Access Compliance Report

Public Rights-of-Way

(Curb Ramps)

Intersection ID: 26038	Main Street: ELM_LN	Cross Street: PINEVILLE-MATTHEWS_RD	Location: NE
ADA ID: 8C85BEF35908	Ramp Type: Perp	Initial Pass/Fail: Fail	Overall Compliance: No
Severity Score: 10			
Codes/Mitigation Info/Possible Solution		Field Measurements/Component Compliance

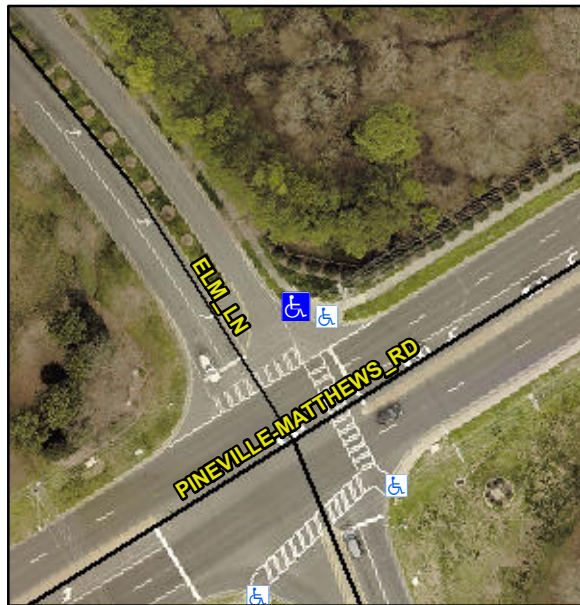
Not Found, R304.5.1, R304.5.3

Compliance	Description	Data	Compliance	Description	Data
N/A	Ramp Length (in)	106.0	Yes	Ramp Slope (%)	5.3
No	Ramp Width (in)	39.0	No	Ramp XSlope (%)	4.0
N/A	Flare Type LT	N/A	N/A	Flare Type RT	N/A
N/A	Flare Slope LT (%)	N/A	N/A	Flare Slope RT (%)	N/A
N/A	Flare Traversable LT?	N/A	N/A	Flare Traversable RT?	N/A
N/A	Landing Length (in)	N/A	N/A	DWS Provided?	N/A
N/A	Landing Width (in)	N/A	N/A	DWS Contrast?	N/A
N/A	Landing Slope (%)	N/A	N/A	DWS Length (in)	N/A
N/A	Landing X Slope (%)	N/A	N/A	DWS Full Width?	N/A
N/A	Landing Curb? (Y/N)	N/A	N/A	DWS Offset (in)	N/A
N/A	Shared Landing?	N/A			
N/A	Gutter Ponding?	N/A	N/A	Gutter Slope (%)	N/A
N/A	Gutter Lip Ht (in)	N/A	N/A	Gutter X Slope (%)	N/A
N/A	Painted X Walk1?	No	N/A	Painted X Walk2?	N/A
	X Walk 1 Direction	To SW		X Walk 2 Direction	N/A
N/A	X Walk 1 Width (in)	N/A	N/A	X Walk 2 Width (in)	N/A
	X Walk 1 Slope (%)	0.5		X Walk 2 Slope (%)	N/A
	X Walk 1 X Slope (%)	2.0		X Walk 2 X Slope (%)	N/A

Remove & Replace Entire Ramp.
